Subject: Duke Energy Carolinas, LLC
William States Lee III Nuclear Station – Docket Nos. 52-018 and 52-019
AP1000 Combined License Application for the
William States Lee III Nuclear Station Units 1 and 2
Supplemental Response to RAI No. 10.04.05-2
Ltr #: WLG2011.11-03

Lee Nuclear Station Supplemental Response to Request for Additional Information (RAI)

Reference NRC RAI Number(s): 10.04.05-2 (Tracking Number 484)

Lee Nuclear Station
Attachment 2 to Supplemental Response to
Request for Additional Information
RAI 10.04.05-02
FSAR Chapter 2 Figure Revisions:
FSAR Figure 2.4.2-202
New FSAR Figure 2.4.2-204
FSAR Figure 2.4.3-234
FSAR Figure 2.4.5-202

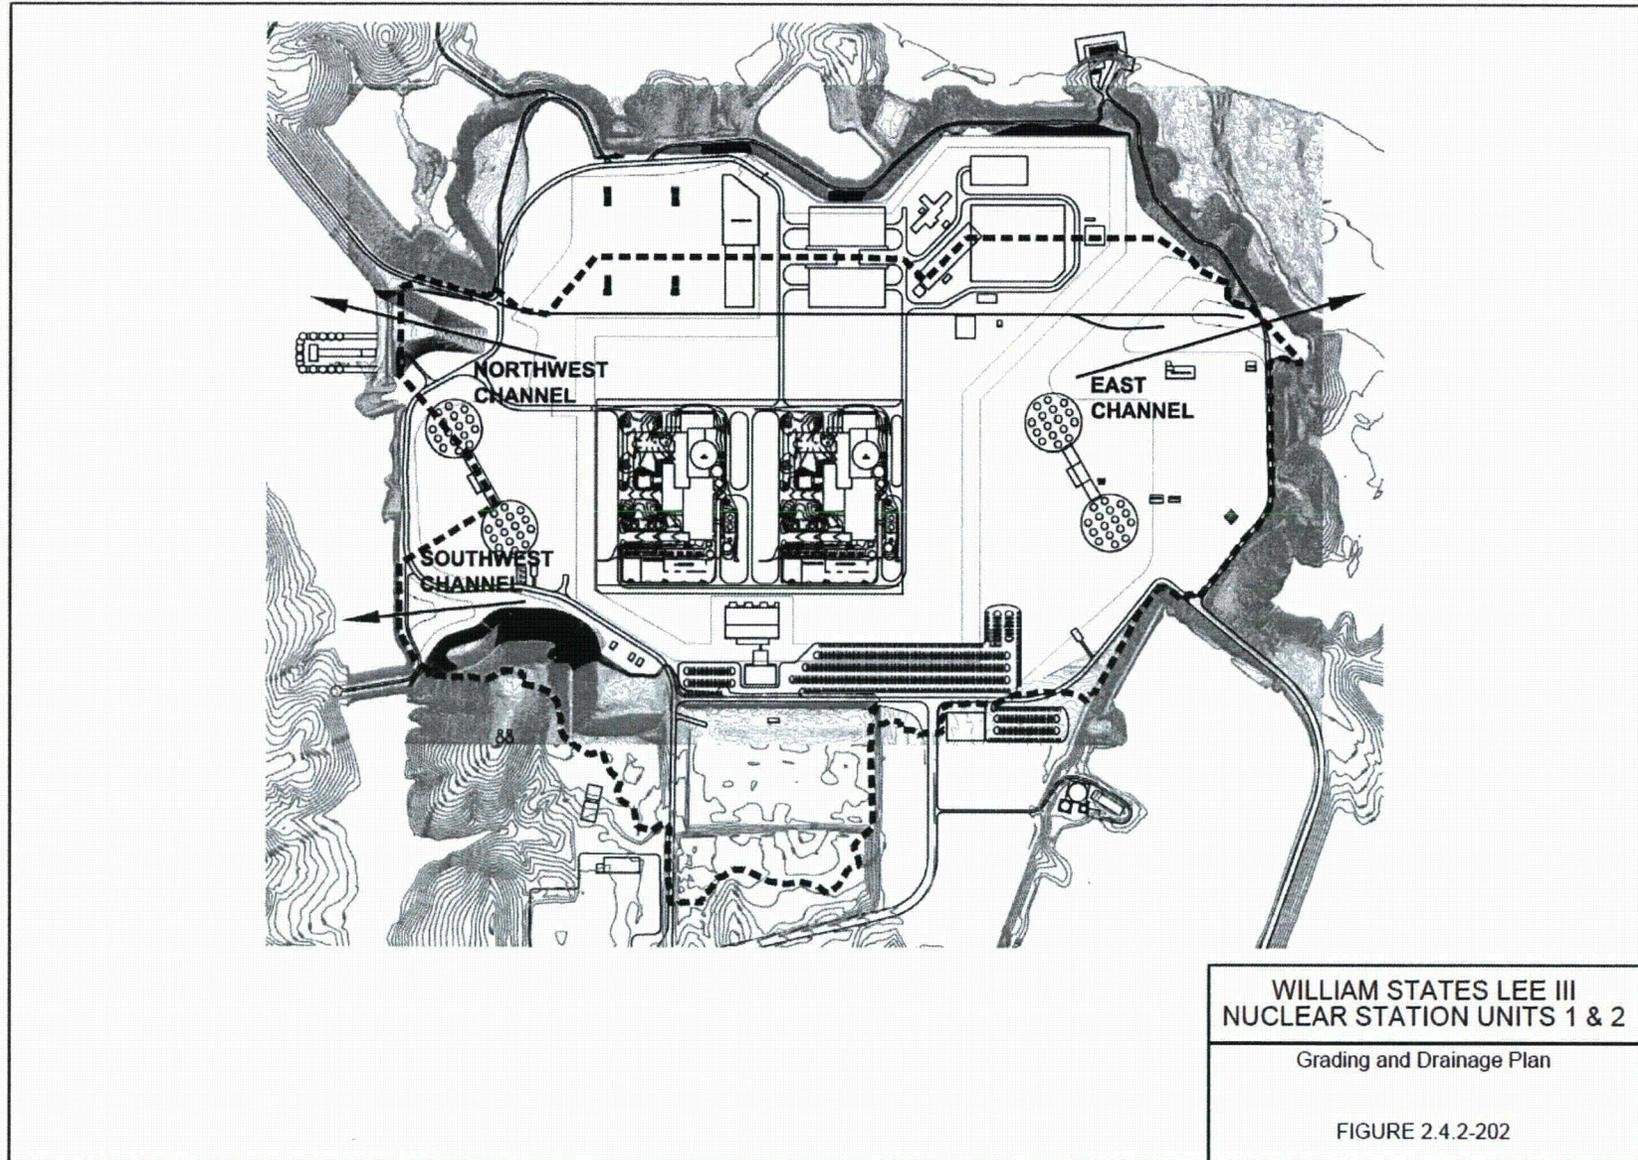
To improve overall site drainage a number of enhancements have been made to the site grading and drainage plan (see revised FSAR Figure 2.4.2-202 in Attachment 2 to this Enclosure). These site enhancements include revisions, additions, and removal of existing and previously planned grading features. The overall site grading has been revised to incorporate the following changes.

- The ridge to the northwest of Unit 1 and the two cooling tower berms on either side of the units have been removed. The cooling tower design has been revised to include two individual towers per unit.

- Drainage flow paths to the Broad River (east channel on revised FSAR Figure 2.4.2-202) and Make-Up Pond B (northwest and southwest channels on revised FSAR Figure 2.4.2-202) have been revised, and the graded drainage flow path to Make-Up Pond A has been removed.

- The grading in the area of the power block has been redefined in more detail. Site contours have been reshaped to promote drainage away from the nuclear island (refer to new FSAR Figure 2.4.2-204 in Attachment 2 of this Enclosure). The finished floor elevation of the Nuclear Island remains unchanged at 590 ft msl.

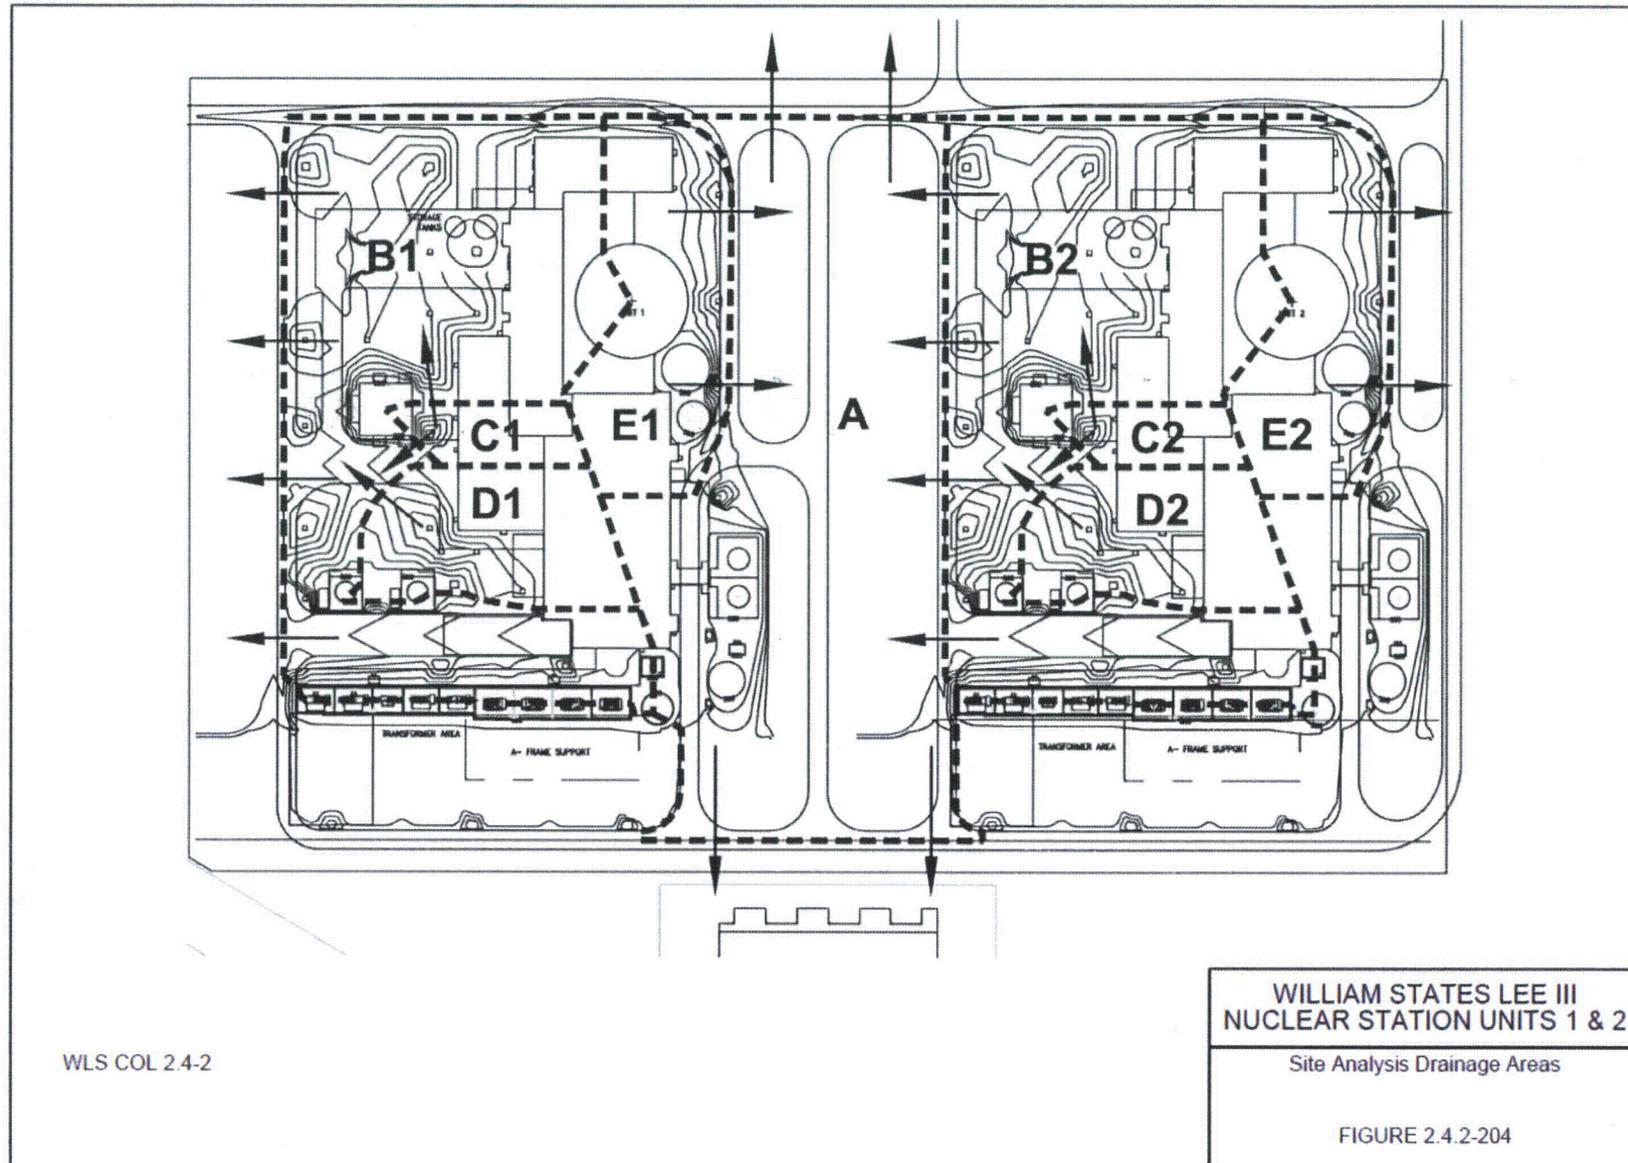
As shown in Figure 2.4.2-204, runoff is directed away from the units to lower lying areas. Under the assumption that all subsurface drainage features are non-functional, runoff would overtop roadways or other topographical features as the flow exits the areas immediately adjacent to the units. Overtopping is evaluated using the standard weir flow equation and two approaches. The first approach is based on simply applying a weir flow coefficient of $C = 2.6$. The second approach is based on roadway overtopping methodology (Reference 304) and adjusting an initial weir flow coefficient of $C = 2.5$ for gravel or $C = 2.9$ for paving to account for weir submergence due to downstream conditions. The more conservative of the results is selected as the maximum water surface elevation.

For each area shown in Figure 2.4.2-204, the peak runoff is determined using the maximum PMP intensity of 6.2 in/5 min from Table 2.4.2-203. The peak runoff is determined by multiplying the drainage area by the intensity and converting the units to cubic feet per second. This approach is essentially equivalent to the Rational Method using a runoff coefficient of one. Therefore, rainfall is converted to runoff instantaneously and no runoff losses are included.

Runoff from Areas A, B1, and E2 overtops the roadway looping around the power block into the site area idealized as a reservoir. Runoff from Areas E1 and B2 overtops interior roadways into Area A. Runoff from Areas C1 and D1 overtops a combination of interior roadways and topographical features into Area B1. Similarly, runoff from Areas C2 and D2 overtops a combination of interior roadways and topographical features into Area B2.

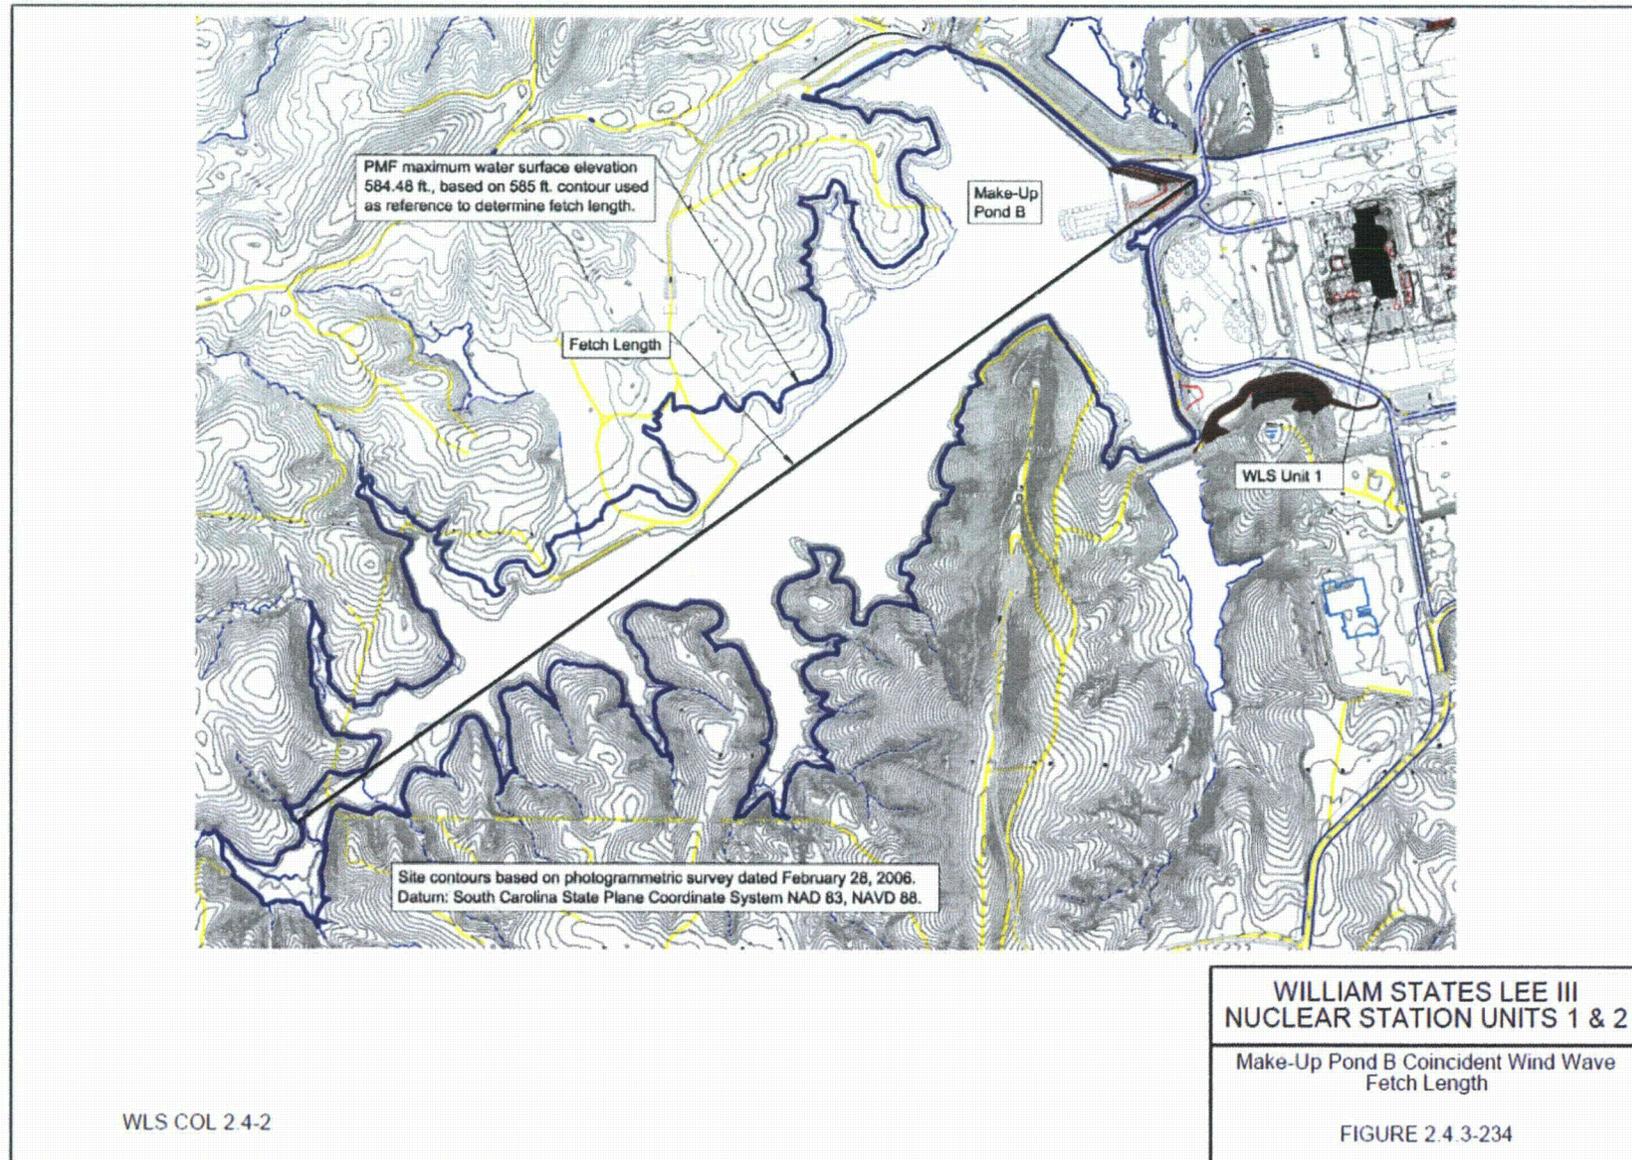
Revised site grading (as shown on revised FSAR Figure 2.4.2-202) required updated analysis of coincident wind wave activity related to Make-Up Pond B (MUPB). Based on this updated analysis, the maximum flood level for MUPB with the added effects of wind wave activity increased from 584.8 ft msl to 585.7 ft msl. The Lee Nuclear Station safety-related structures have a grade elevation of 590 ft. msl.

- FSAR Subsections 2.4.1.2.2.6, 2.4.2.2, 2.4.3.6, 2.4.14 and Table 19.58-201 will be revised to reflect the results of this updated analysis.
- FSAR Figure 2.4.3-234 (critical fetch length) will also be revised consistent with this updated analysis.

Wind wave activity on Make-Up Pond B is evaluated coincident with the maximum water surface elevation of the PMF as discussed in Subsection 2.4.3.5. The determined critical fetch length of ~~1.48~~1.47 mi. is shown in Figure 2.4.3-234. The 2-year annual extreme mile wind speed is adjusted based on the factors of fetch length, level overland or over water, critical duration, and stability. The critical duration is approximately ~~36~~35 min. The adjusted wind speed is ~~50.22~~50.33 mph.

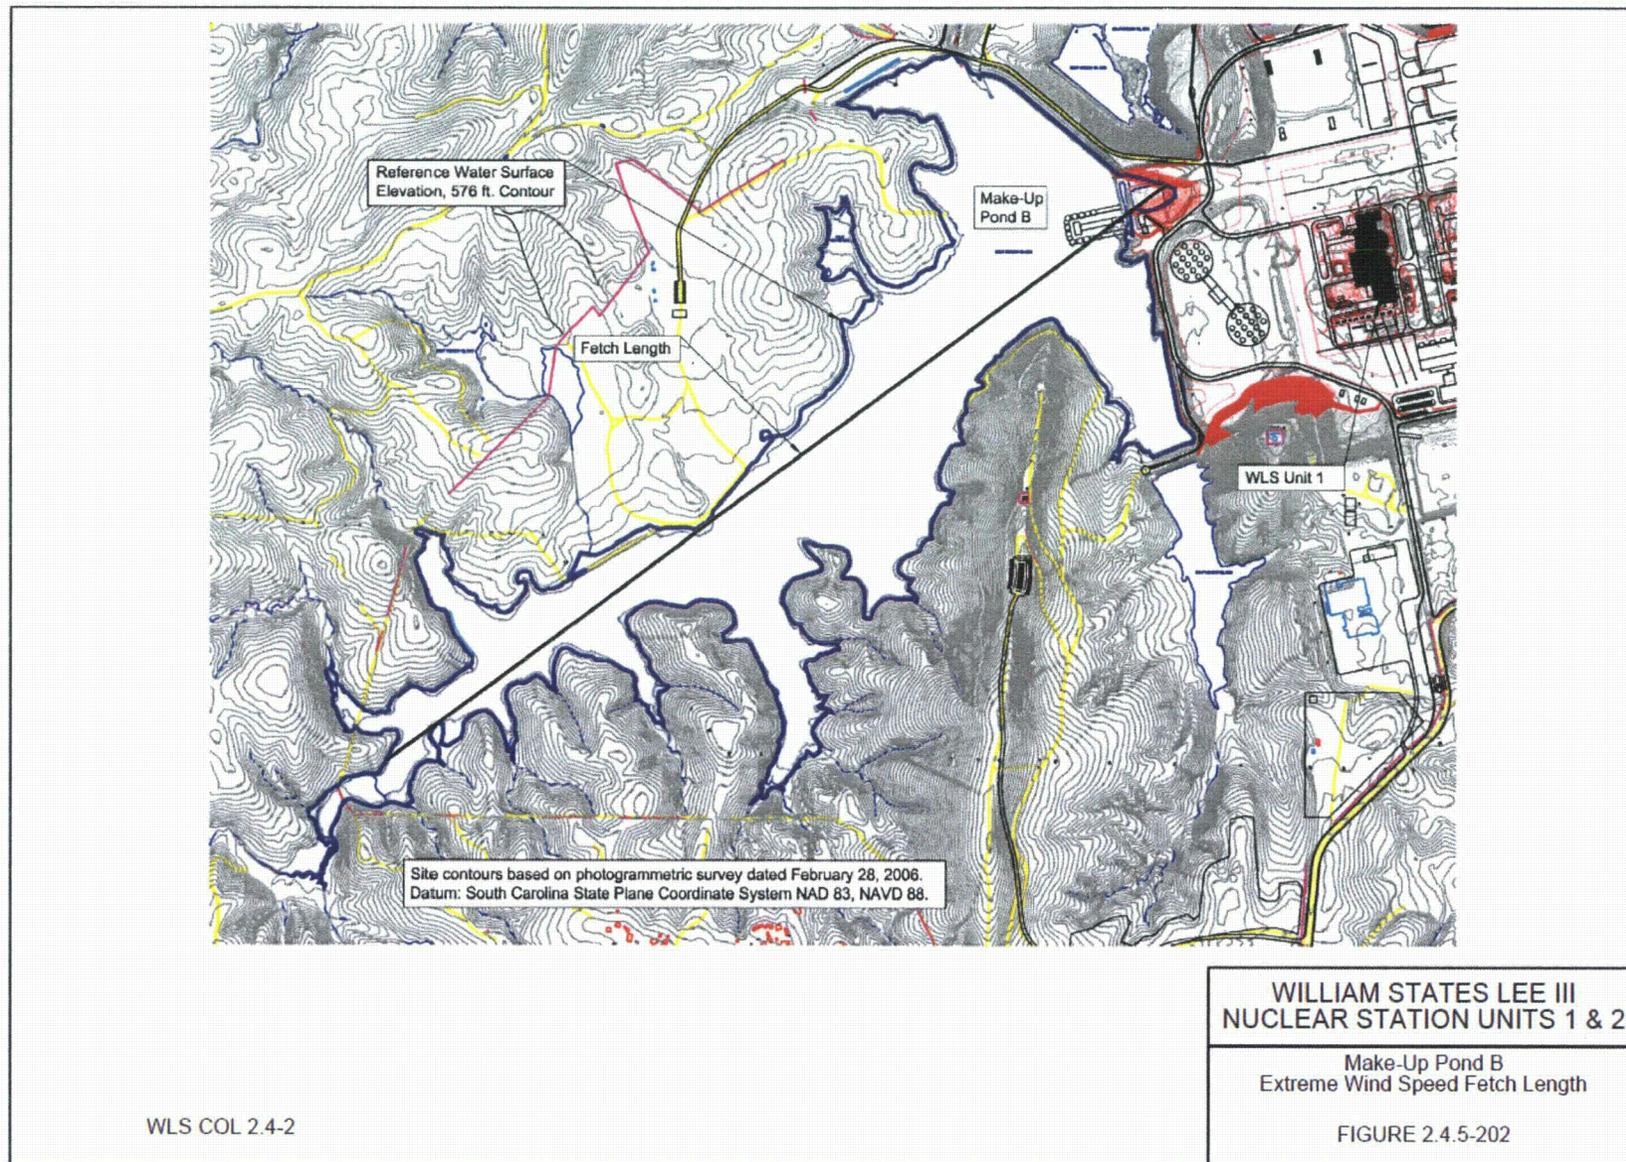
The revised site grading also required an updated analysis of surge and seiche flooding for MUPB. FSAR Subsection 2.4.5 will be revised to provide the related updates resulting from these analyses. FSAR Figure 2.4.5-202 will also be revised to provide an updated critical fetch length associated with surge flooding.

Make-Up Pond B surge flooding is evaluated coincident with the 100-yr. water surface elevation of 576.22 ft. The critical fetch length is ~~1.21~~1.30 mi. as shown in Figure 2.4.5-202. The wind speed is adjusted based on the factors of fetch length, level overland or over water, critical duration, and stability using U.S. Army Corps of Engineers guidance (Reference 295). The critical duration is ~~21~~26 min. The adjusted wind speed is ~~90.6~~90.1 mph.
